BID ADDENDUM NO. 3

CONSTRUCTION NEW GEORGE WYTHE HIGH SCHOOL (RHSA)

**IFB # 23 – 7061 – 11
RRMM Project # 21310 – 00**

**January 4, 2024
Architect of Record:
RRMM, Architects, PC
1317 Executive Boulevard
Suite 200
Chesapeake, VA 23320
Phone: 757-213-6350**

ELECTRICAL SITE PLAN - ATHLETIC FIELD LIGHTING

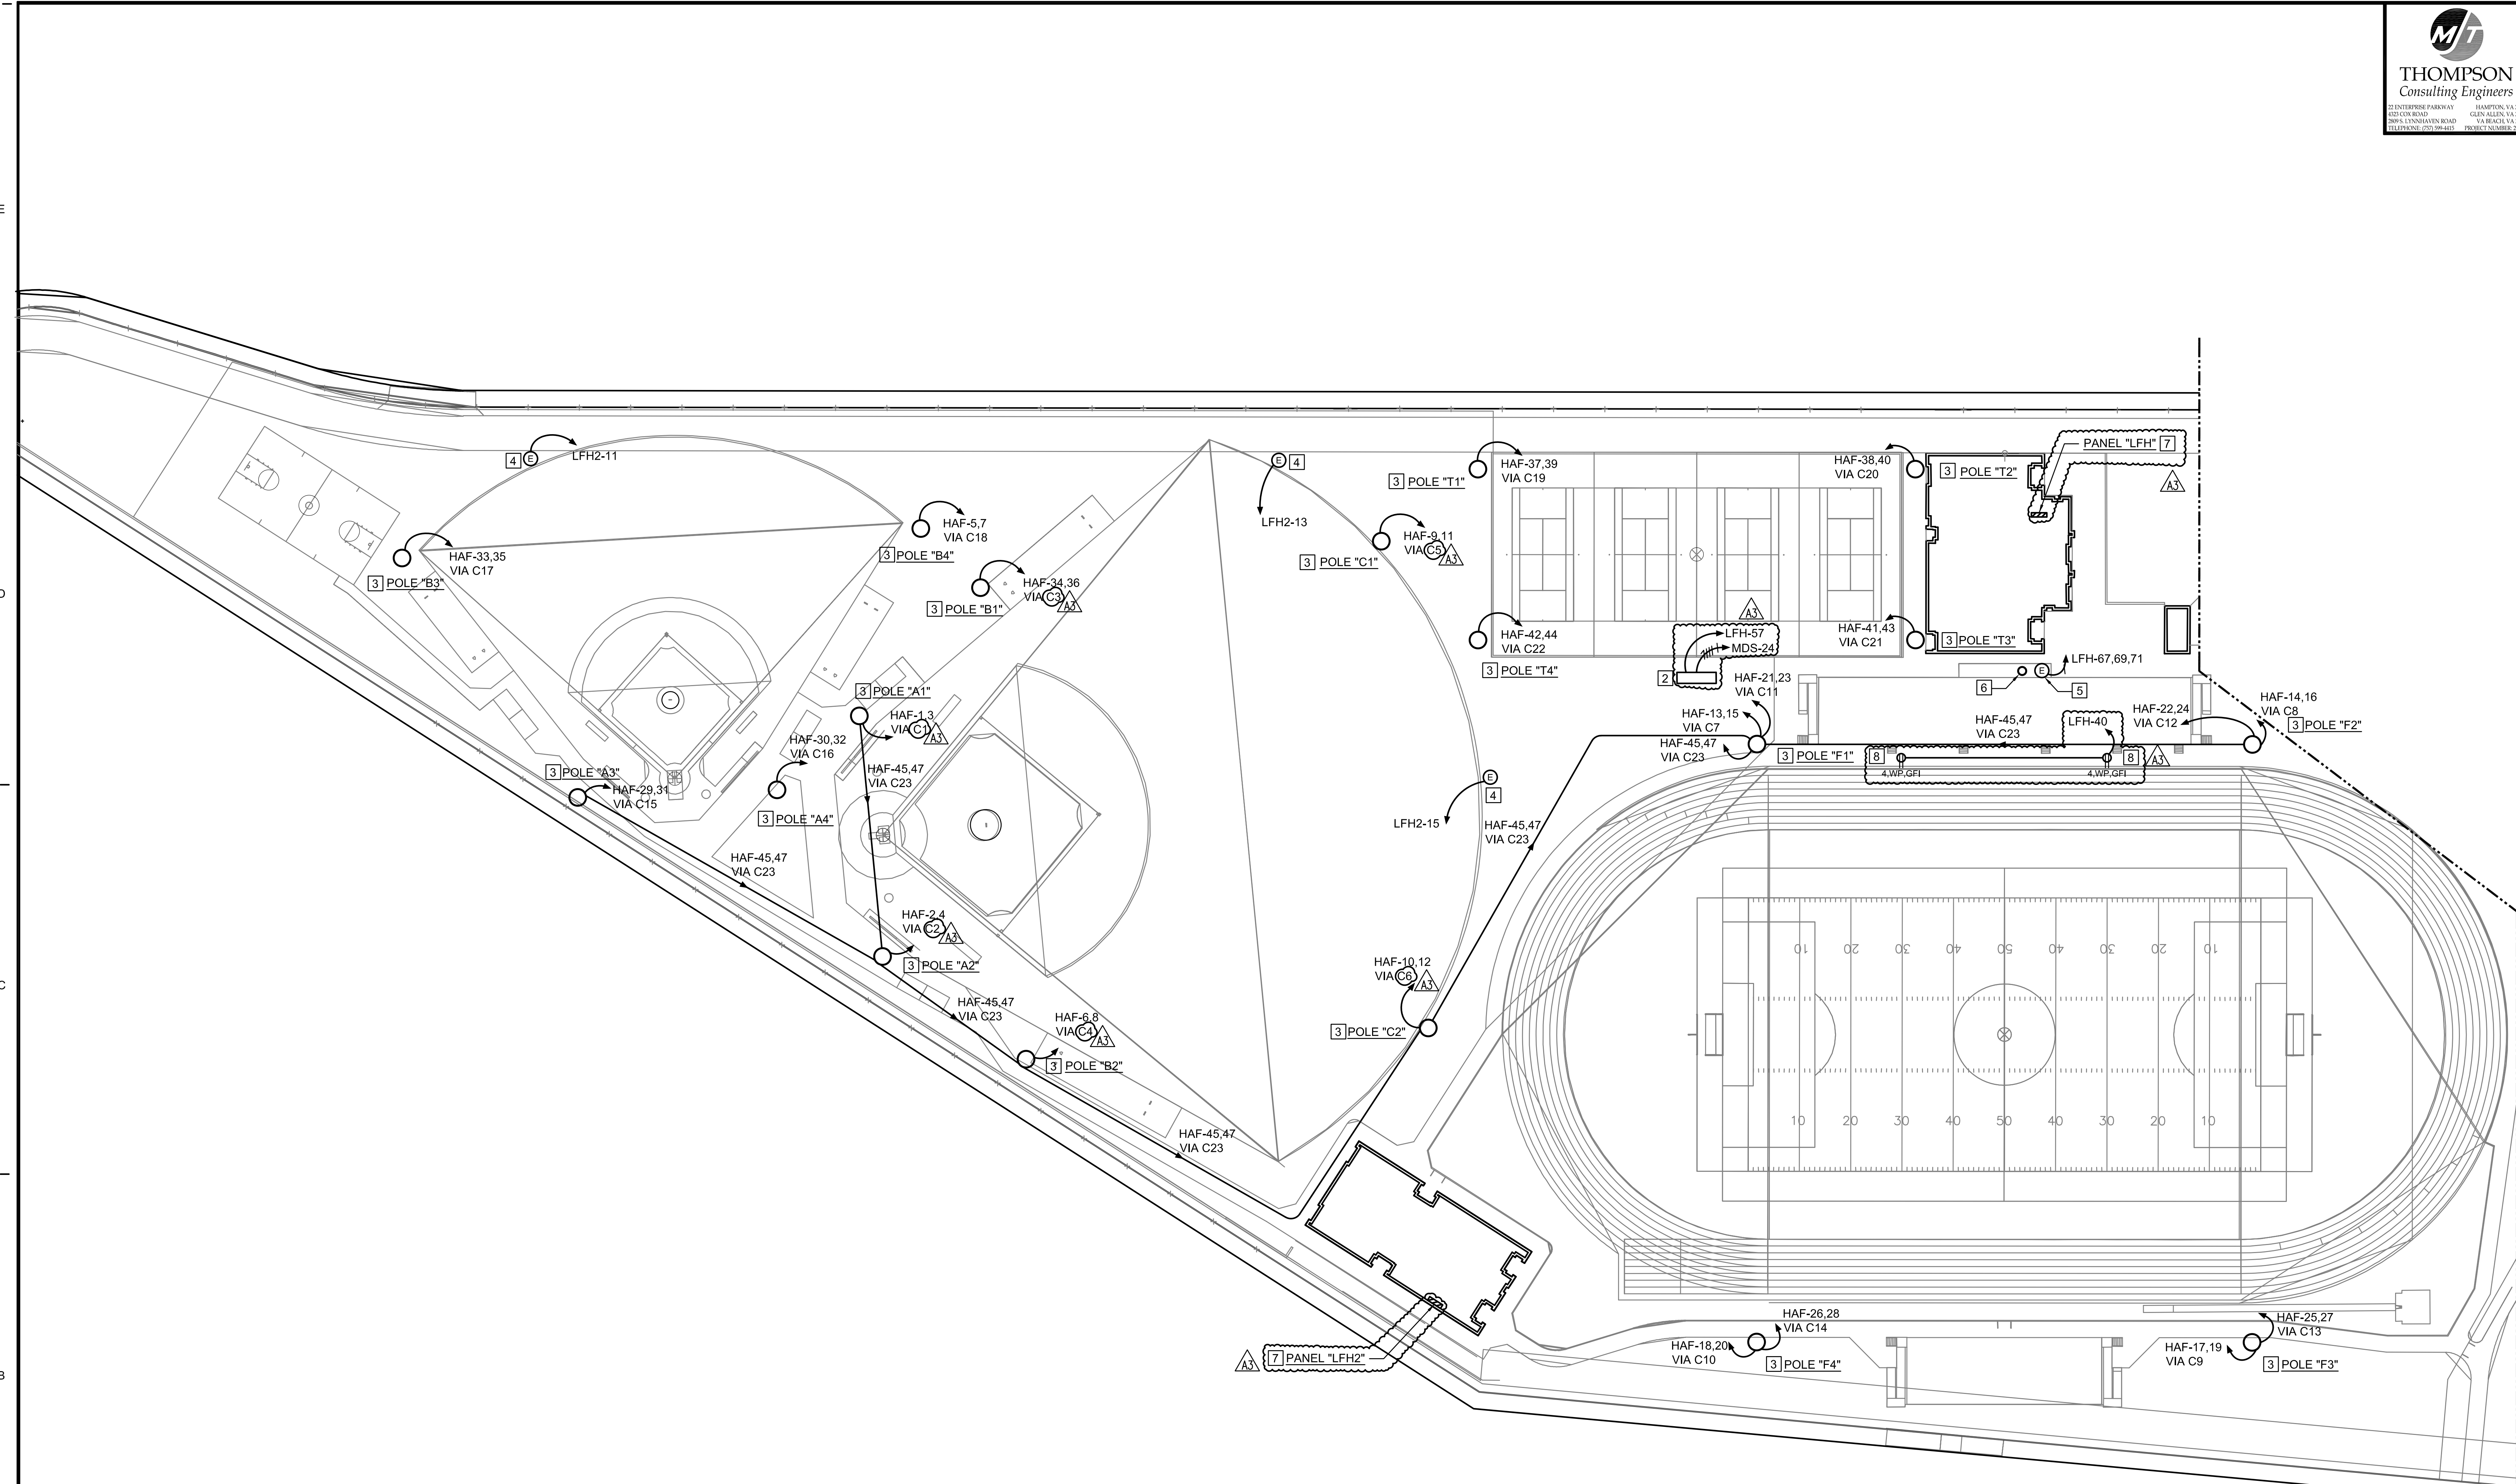
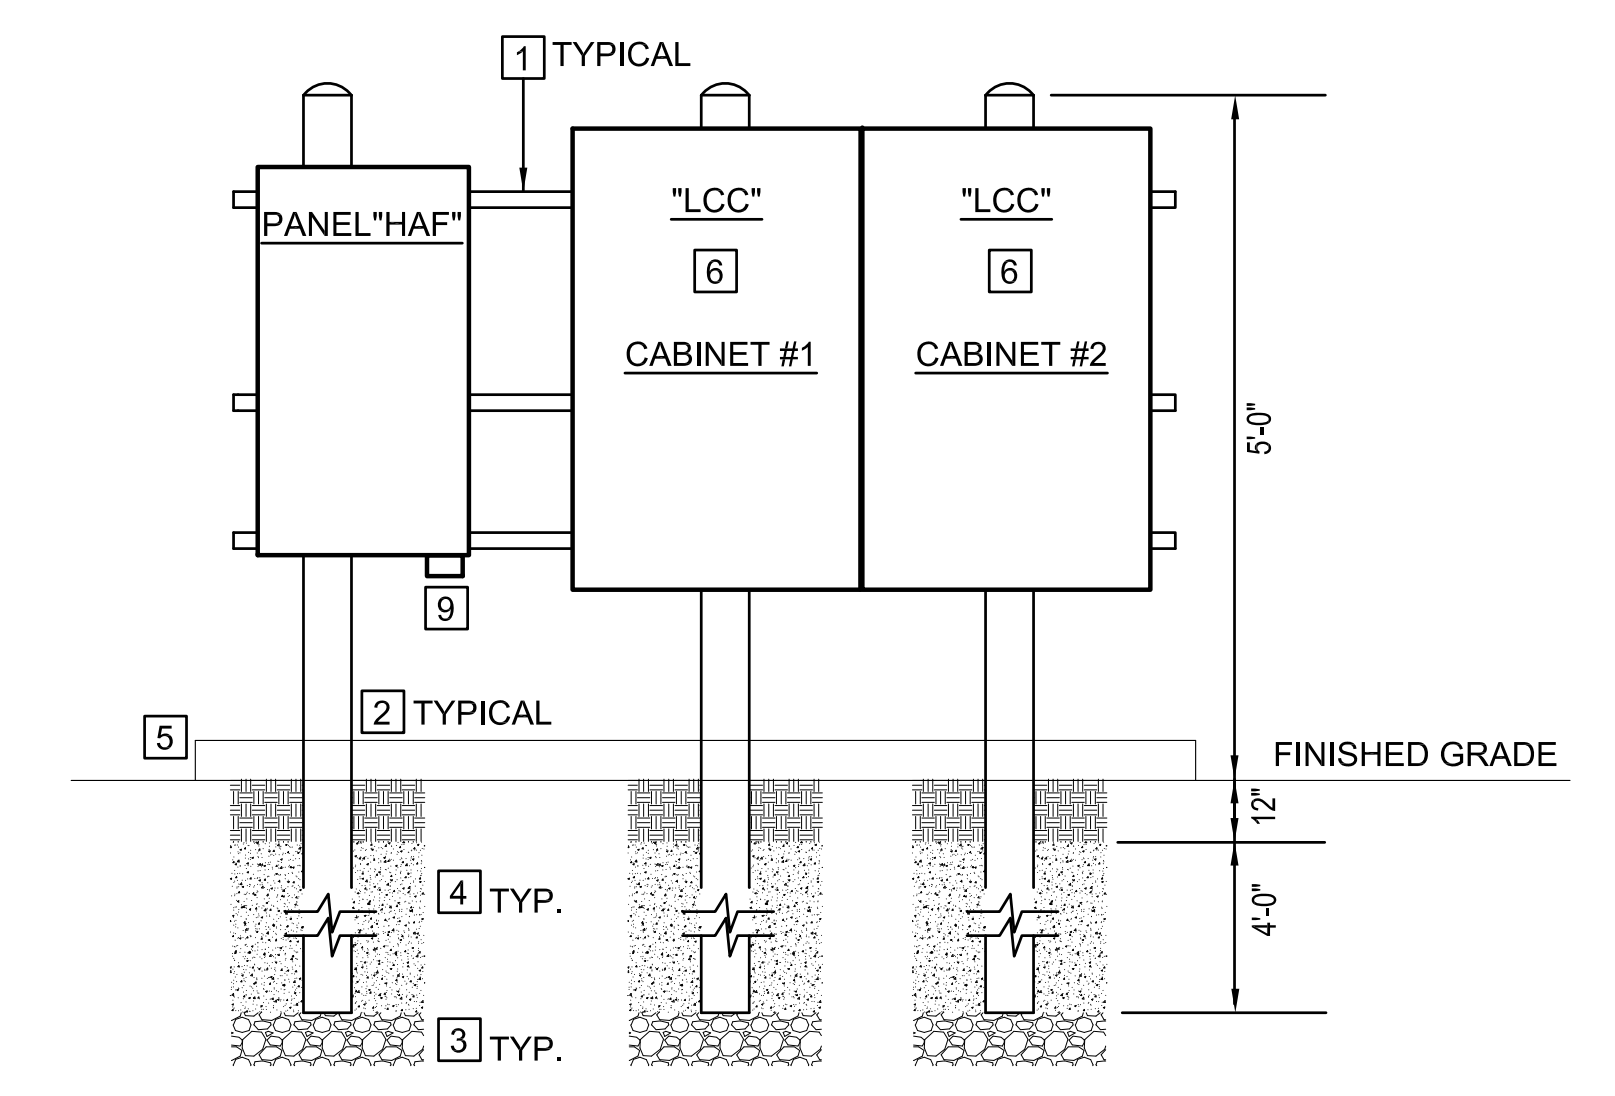
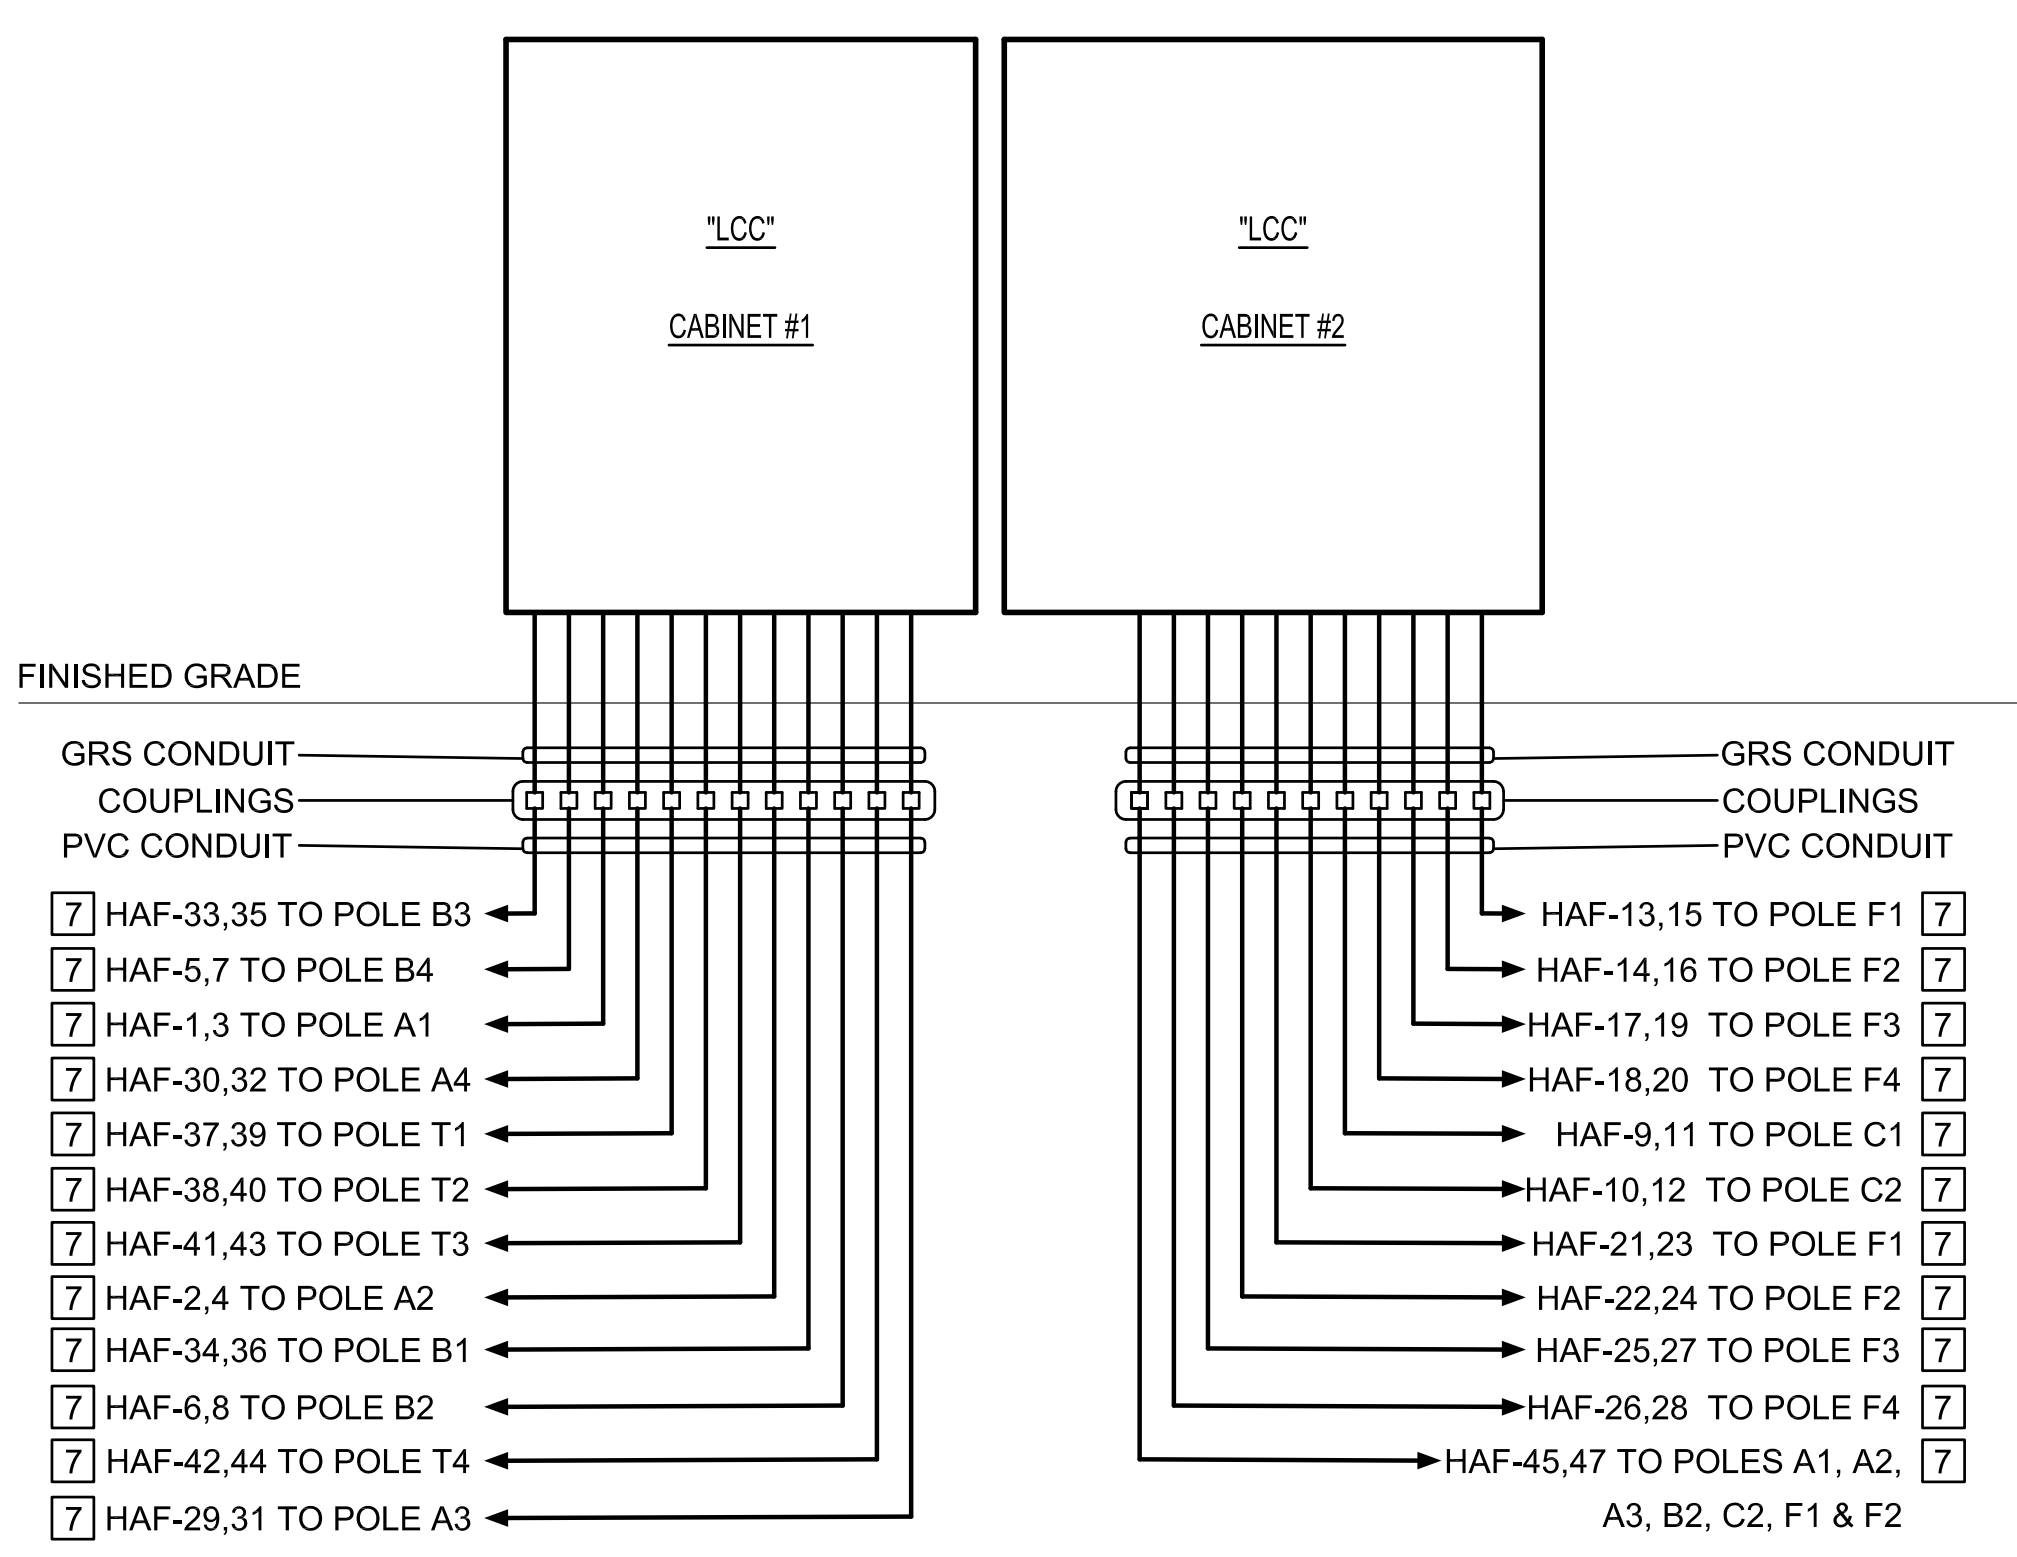
3.27 SHEET E-702 – ELECTRICAL SITE PLAN – ATHLETIC FIELD LIGHTING:

- **REVISE** construction notes per the attached revised sheet.
- **ADD** power pedestals near the home bleachers per the attached revised sheet.
- **ADD** panels “LFH” and “LFH2” per the attached revised sheet.
- **REVISE** contactors for poles A1, A2, B1, B2, C1 and C2 per the attached revised sheet.
- **ADD** feeders for panel “HAF” and lighting control panels per the attached revised sheet.
